## DEPARTMENT OF SUSTAINABLE DEVELOPMENT PLANNING & ZONING DIVISION

RE: VCA

**Administrative Application PZ-14120014**

DEVELOPMENT REVIEW COMMITTEE (DRC) REVIEW #3
2-9-15

# TRELLIS DETAILS

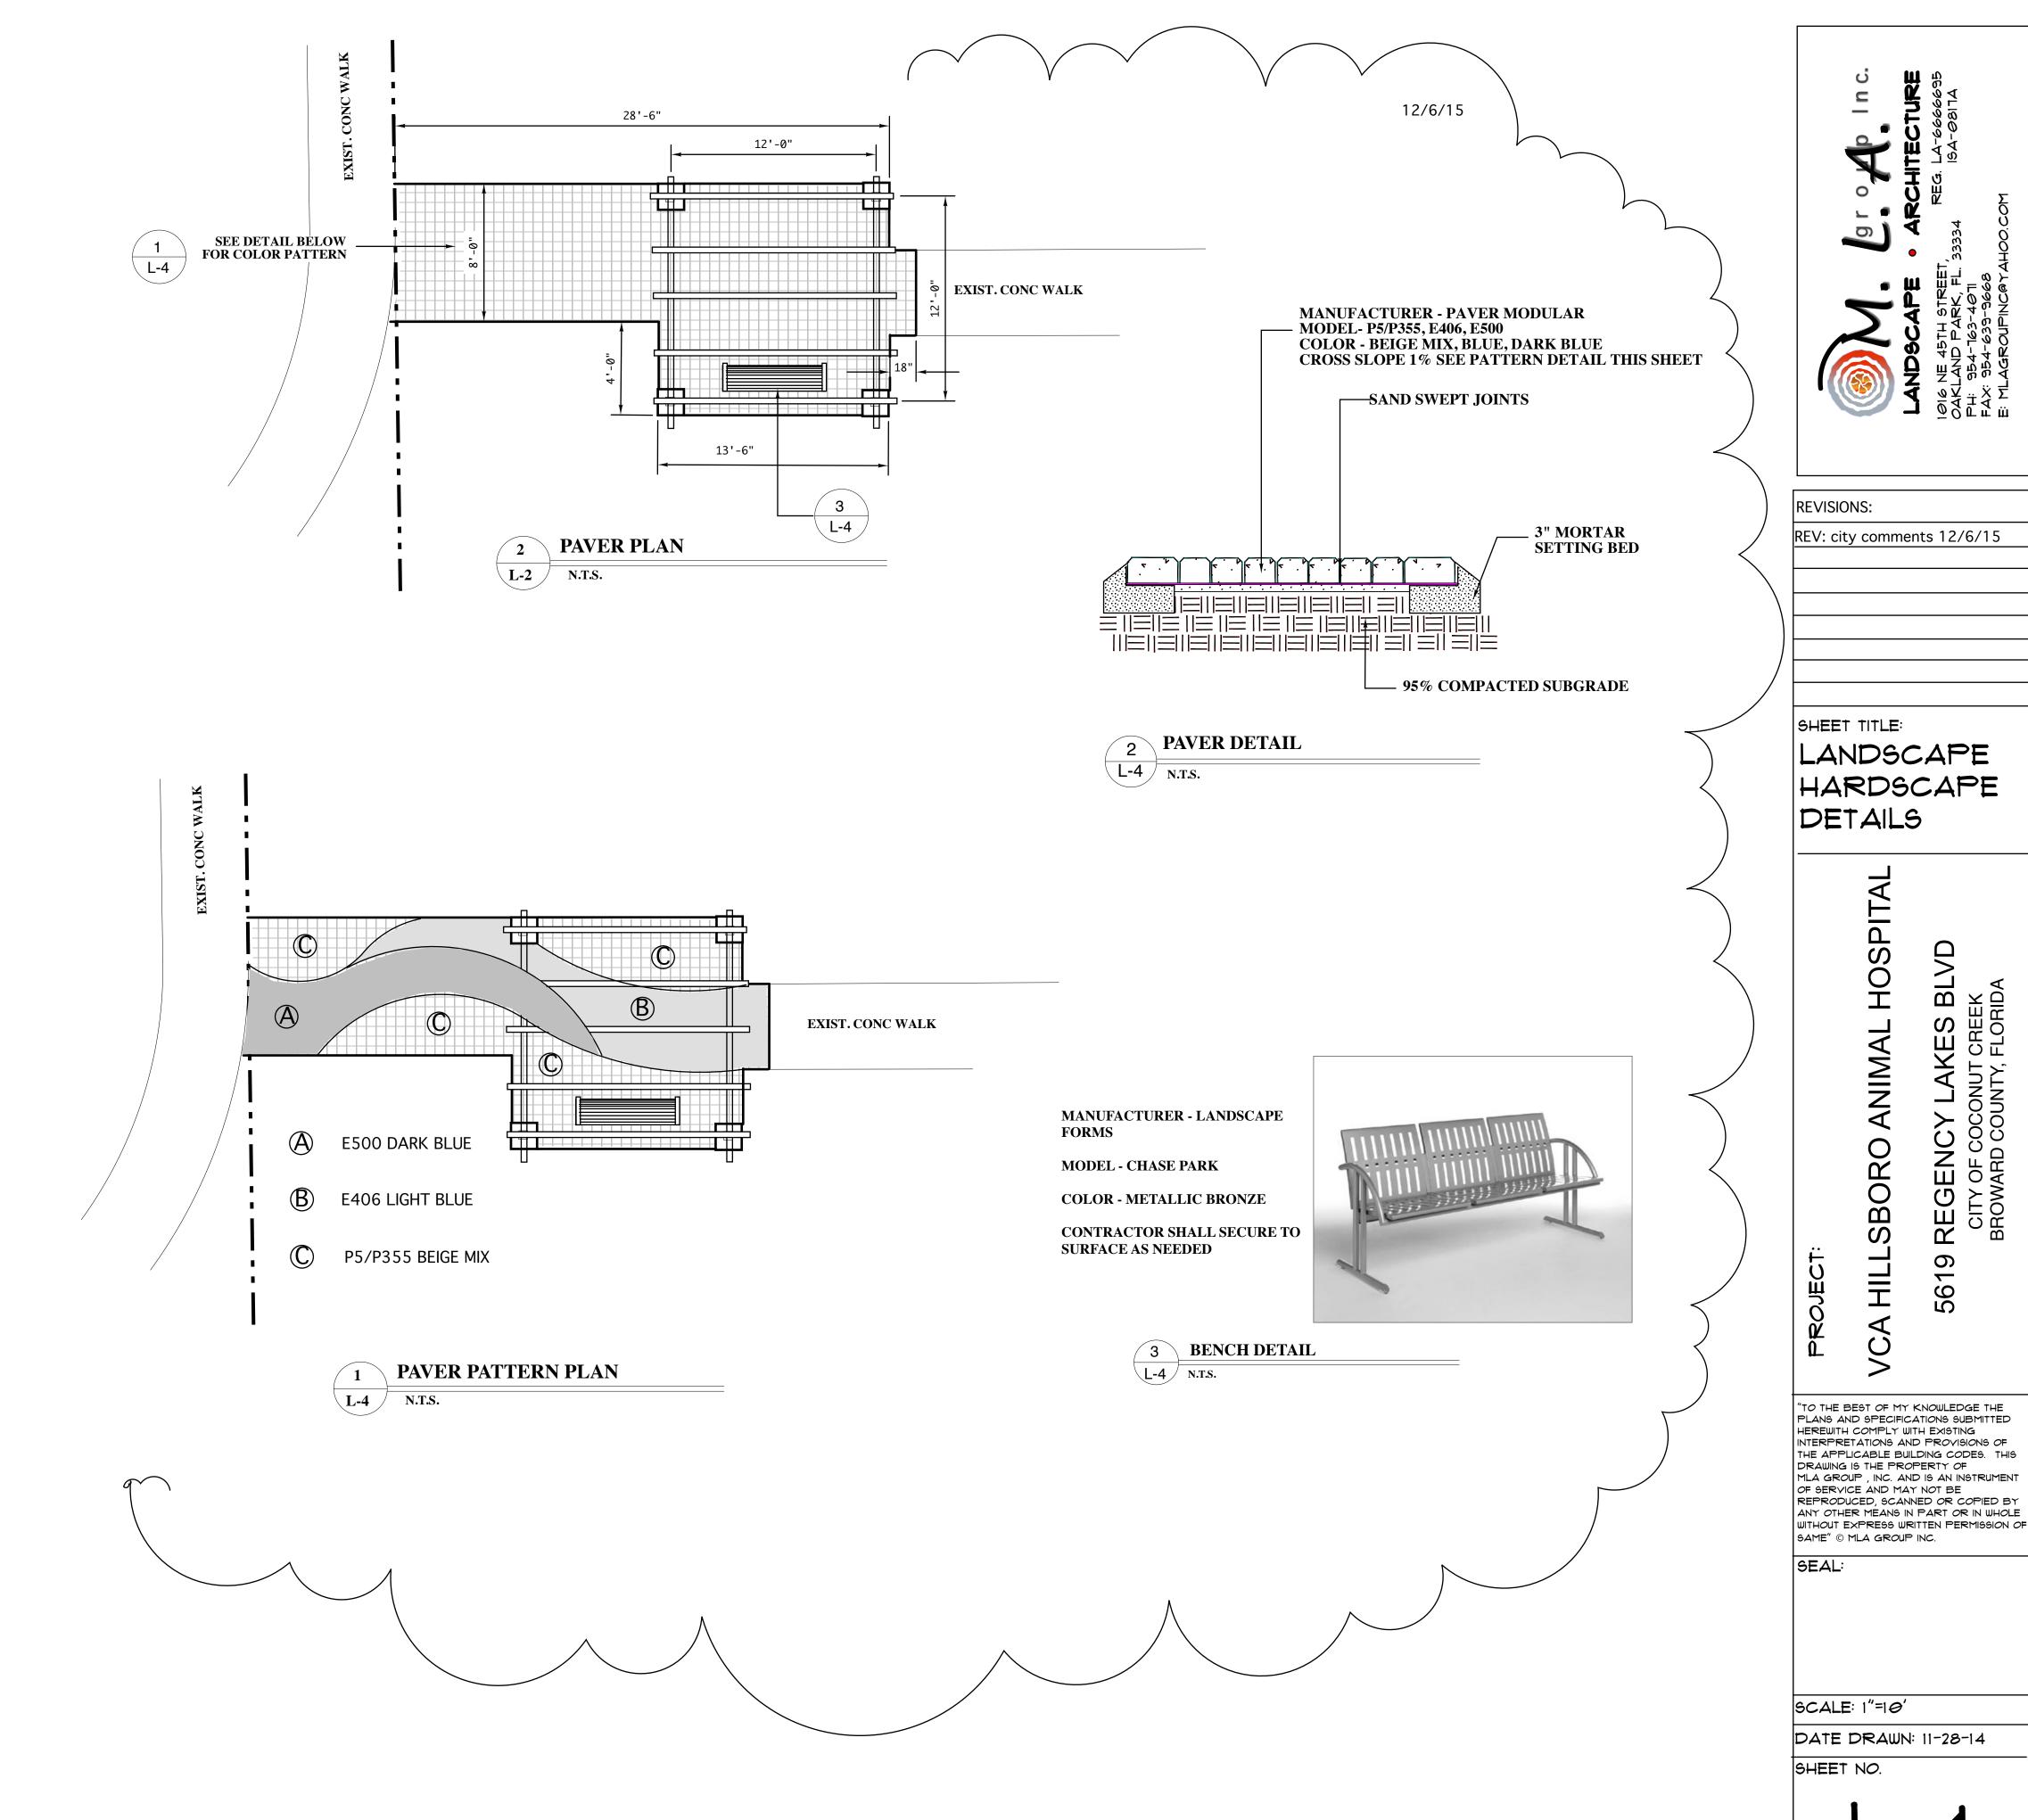
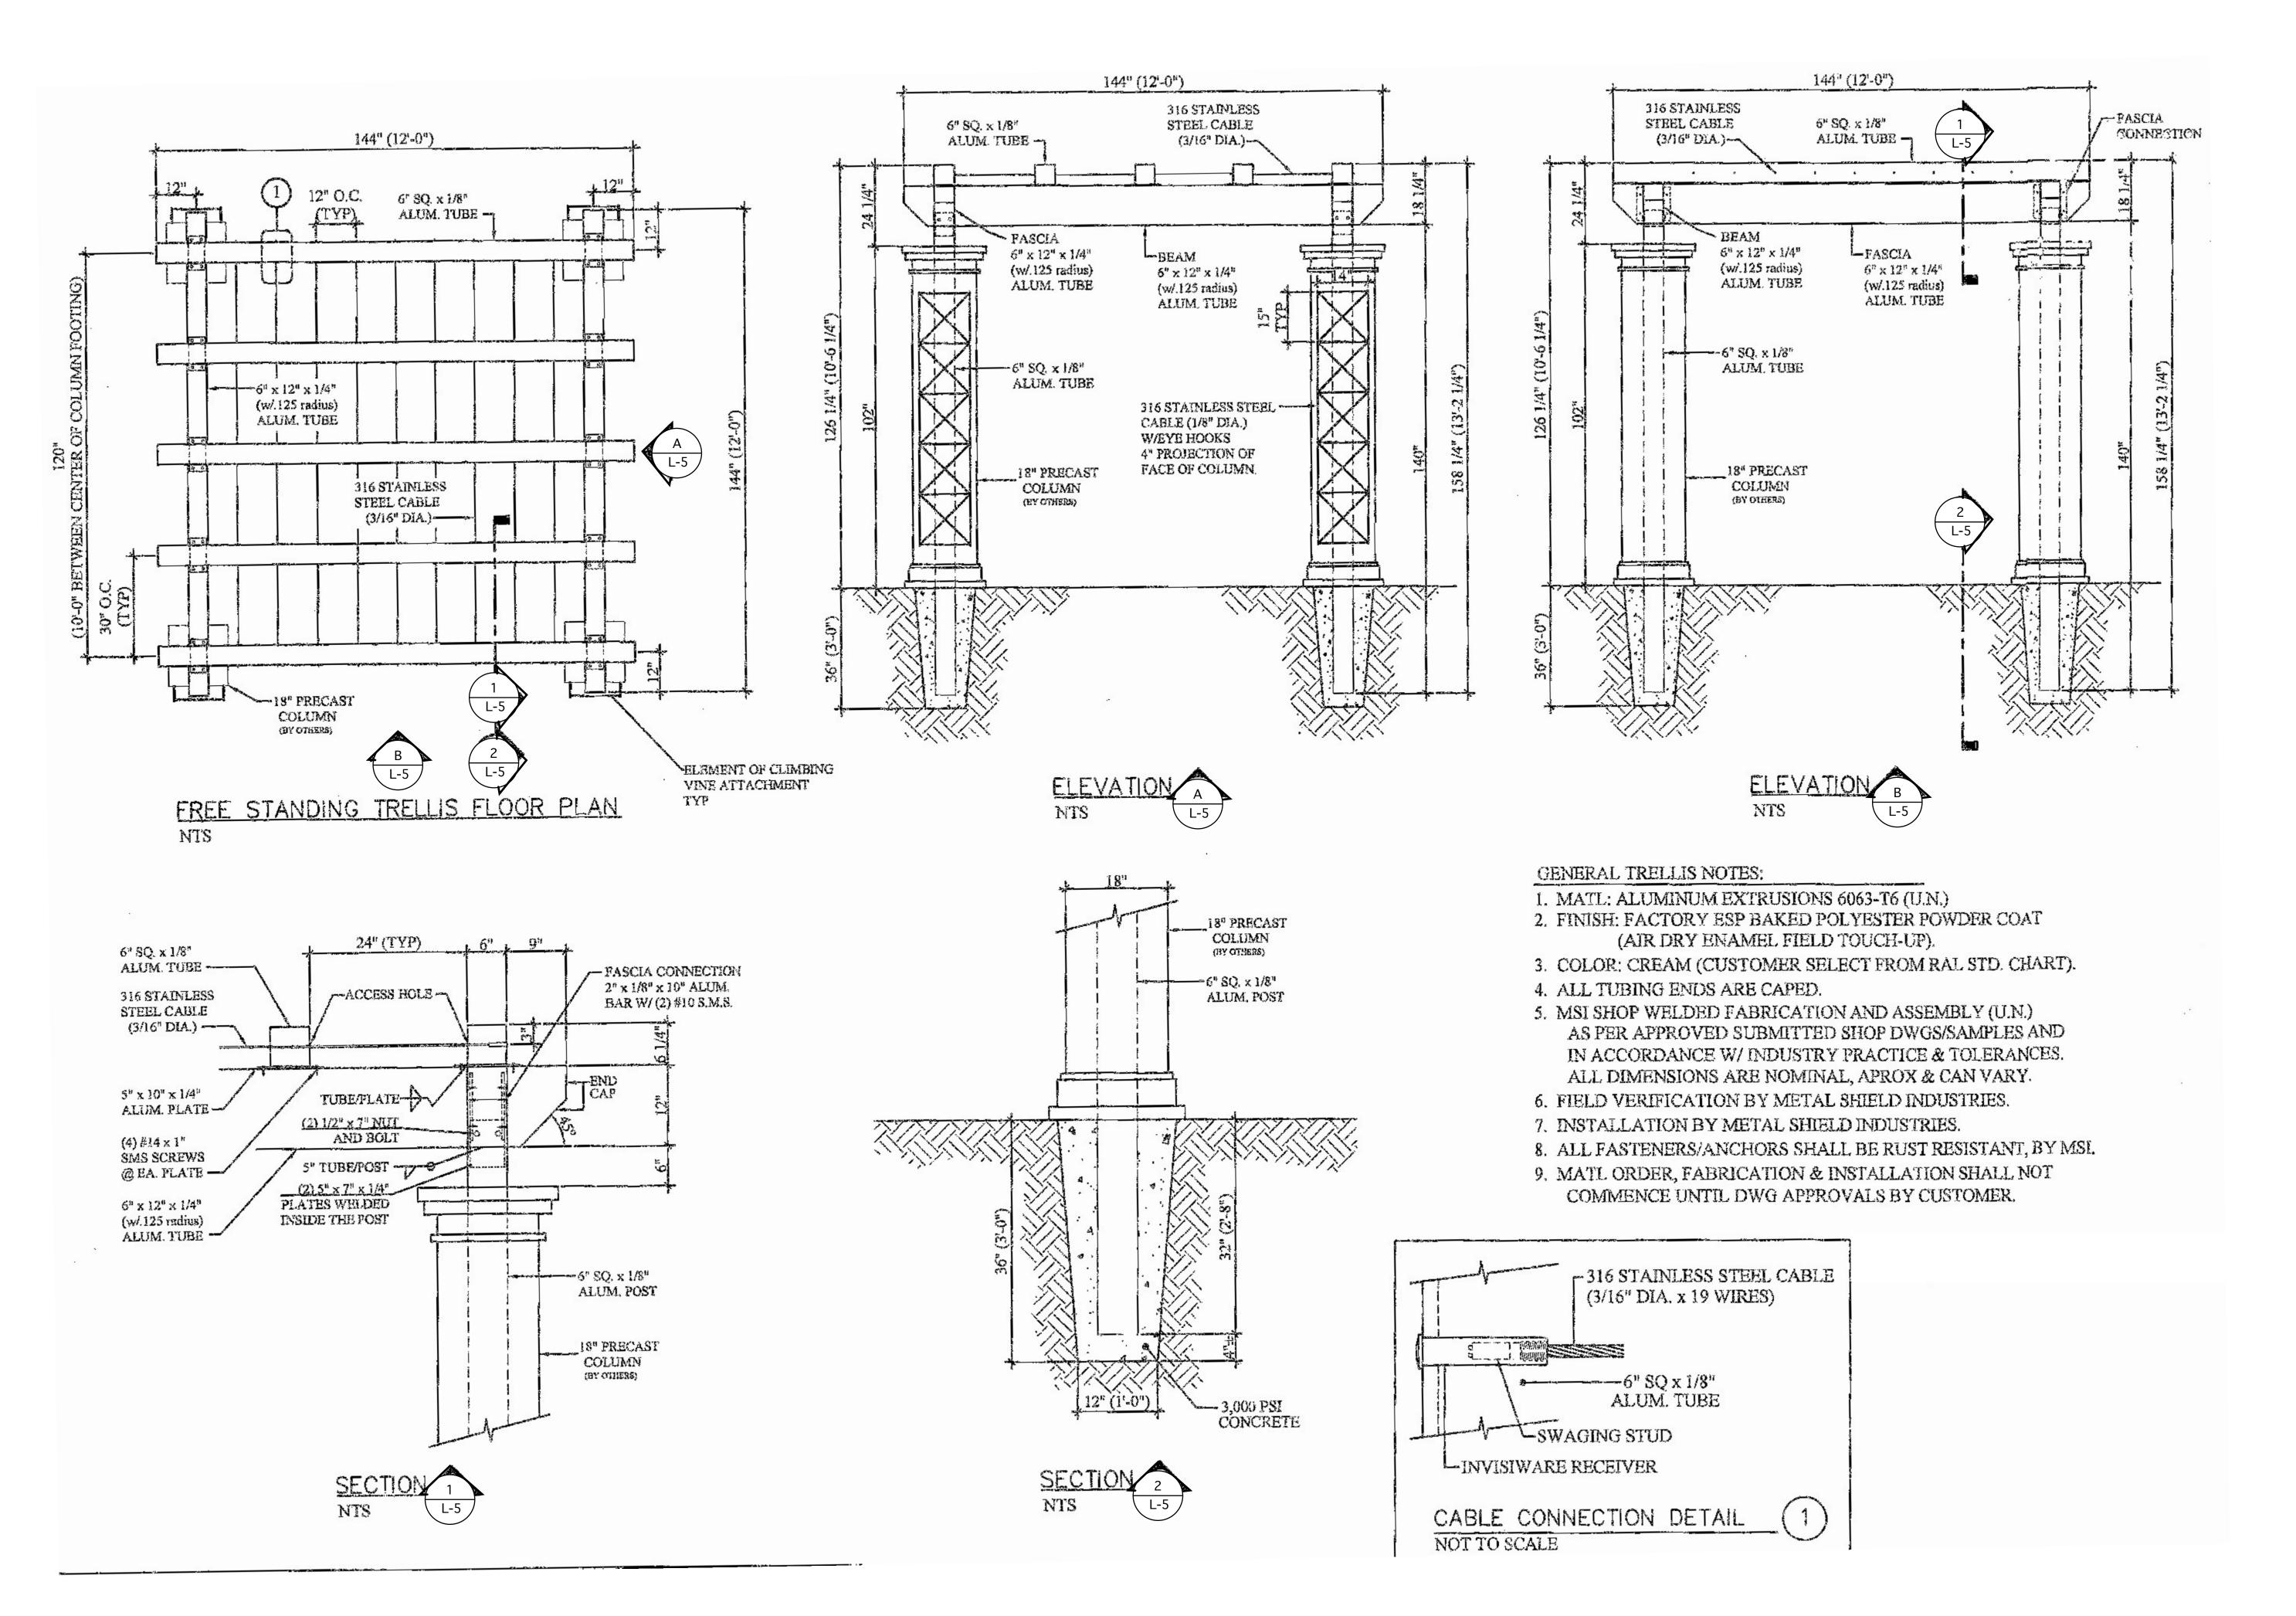
- 1. Application Expiration: Be advised that any Administrative Approval application inactive for more than 6 months will be considered null and void and any application submitted will be treated as a new application with applicable fees.
- 2. The proposed bench must have center arms as shown on the City of Coconut Creek's Amenities Package. Please ensure that the trellis columns wraps are cream colored and the beams (exposed metal) are metallic bronze.
